U.S. Department of Energy
Office of Civilian Radioactive Waste Management

Subissue 3, Thermal-Mechanical Effects on Underground Facility Design and Performance - Component 3, Thermal Effects on Flow into Emplacement Drifts

**DOE-NRC Technical Exchange on the Key Technical Issue
and Subissues Related to Repository Design and Thermal-
Mechanical Effects**

**February 6-8, 2001
Las Vegas, NV**

Figure 1. Parameters Used for Calculation of Mode II Stress Intensity Factor

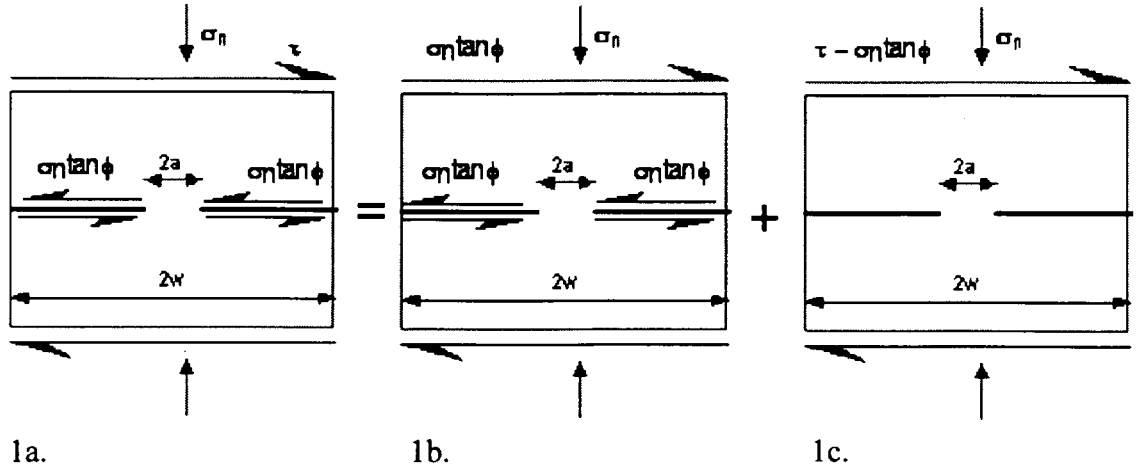
- (6) Provide clarifications for the following items: It is not clear how Equations (I-1) and (I-2) have been developed following Kemeny (1991) and Kemeny and Cook (1986). Contrary to what is assumed in Attachment I, a crack propagating under mode II shear load will not propagate in a direction along the crack axis. Equation (I-3) suggests an inherent assumption of sub-critical crack growth. However, by definition, a joint (crack) cannot continue to grow within an existing crack segment.

RESPONSE: Somewhat expanded derivations for Equations (I-1) and (I-2) are given as follows:

Consider a single asperity of width $2a$ contained in a body of width $2w$ under a far-field shear stress τ and normal stress σ_n , as shown in Figure 1a. Also, assume ϕ is the friction angle for the joint surfaces on either side of the asperity. This will result in frictional stresses along the joint surfaces of $-\sigma_n \tan \phi$.

By linear superposition, the body under the boundary conditions in Figure 1a is equivalent to the sum of the same body with boundary conditions shown in Figures 1b plus those shown in Figure 1c. In Figure 1b the body is subjected to a far-field shear stress $\sigma_n \tan \phi$ and a normal stress σ_n along with frictional stresses along the joint surfaces of $-\sigma_n \tan \phi$. In Figure 1c the body is subjected to a far-field shear stress $\tau - \sigma_n \tan \phi$ and a normal stress σ_n but no tractions along the joint surfaces. Note that Figure 1c is a frictionless problem and can be handled by standard fracture mechanics theory. The boundary conditions in Figure 1b result in no deformation and no stress intensity factor and can be discarded. Therefore from the standpoint of fracture deformation and stress intensity factor, Figure 1a is equivalent to Figure 1c. From Rooke and Cartwright (1976) the mode II stress intensity factor for the geometry and boundary conditions shown in Figure 1c is given by:

$$K_{II} = \frac{(\tau - \sigma_n \tan(\phi))2w}{\sqrt{\pi a(t)}} \quad (1)$$

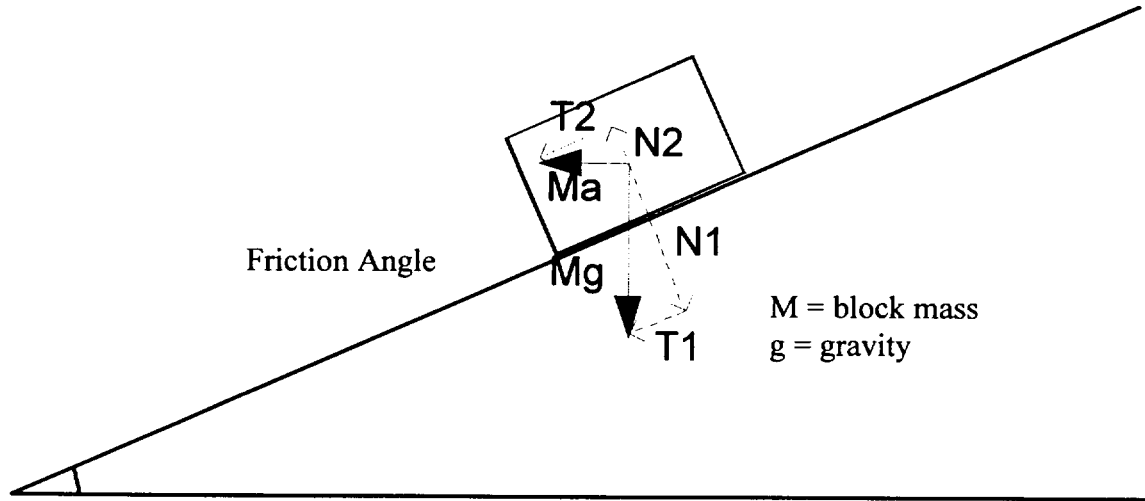
- (2) Demonstrate how the inputs to the verification model will be reasonably identical to the inputs used for the DRKBA model with respect to the following:

RESPONSE: DOE will respond to this during the Technical Exchange for RDTME.
